Natural Denim Ltd (new building)

532, Tongabari, Savar, Dhaka

9th October, 2016

Observations

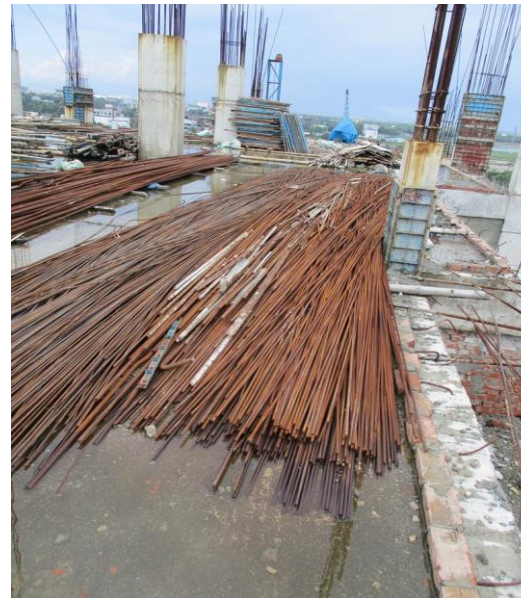
Construction debris and material was piled up in roof, exceeding design loading for current roof

Construction debris and material piled up at current roof, which may exceed the design loading of floor capacity. Building engineer requires to actively maintain the construction material that not exceed the floor capacity.

Item No.	Observation	Recommended Action Plan	Recommended Timeline
1	Construction debris and material was piled up in roof, exceeding design loading for current roof floor.	Implement better control to prevent overload of floors by construction materials and derbies.	Immediate - Now
2	Construction debris and material was piled up in roof, exceeding design loading for current roof floor.	Implement better supervision of floor loadings in storage areas.	6-weeks
3	Discrepancies between drawings & on-site observations.	Engage a Building Engineer to survey the structure and update a full set of “as-constructed” drawings for Structural and Architectural.	6-weeks
4	Columns susceptible to impact loading	Building engineer to design appropriate impact protection for critical column within loading dock.	6-weeks
5	Columns susceptible to impact loading	Construct and maintain protection to critical column and continue to assess likelihood of vehicle impact to critical elements.	6-months

Discrepancies between drawings & on-site observations

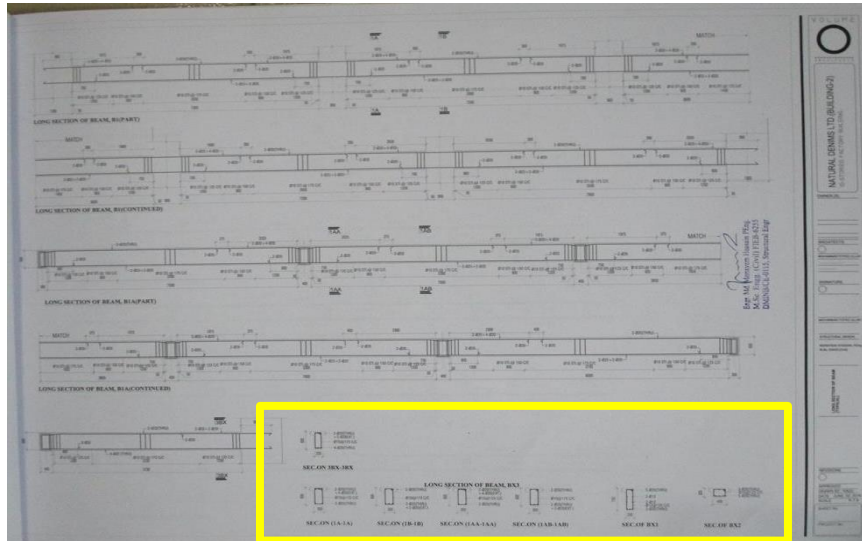
As built structural drawing shows main beam and sub/Secondary beams are same depth. It was observed that sub/secondary beams are minimum of 20 mm shorter than main beam.

Columns susceptible to impact loading

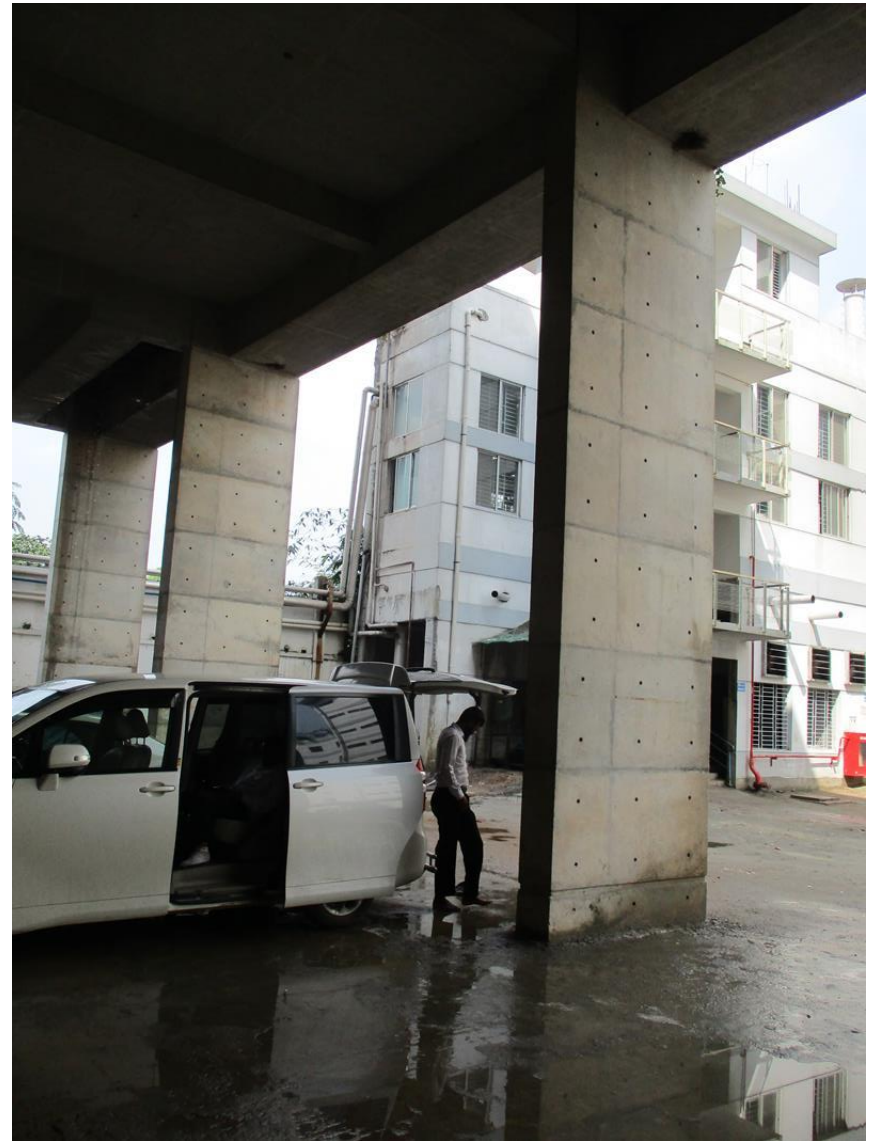
Columns at Loading Bay are susceptible to impact loading from vehicles.

Water ponding and vegetation at roof

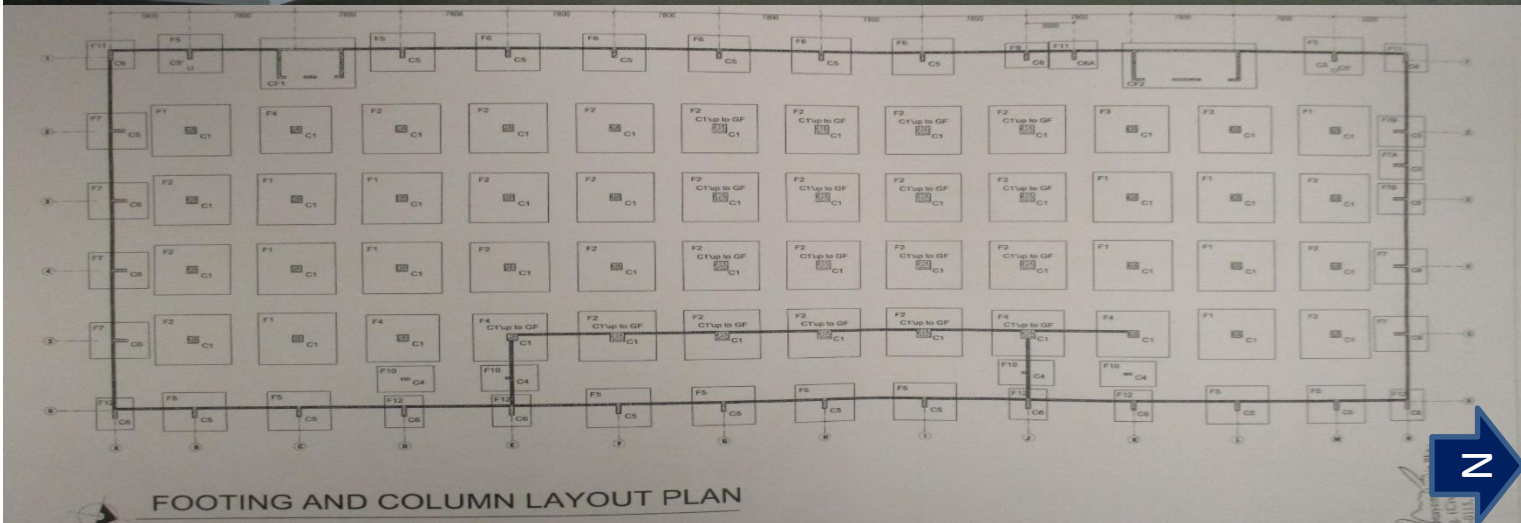
Water ponding at roof was observed and it cause vegetation at roof that also indicates poor drainage system. Building engineer requires to provide water proof coating and improve drainage system.

6	Water ponding and vegetation at roof	Waterproofing on the roof slab is to be applied. Moreover the roof slab drainage system should be investigated and improved.	6-months
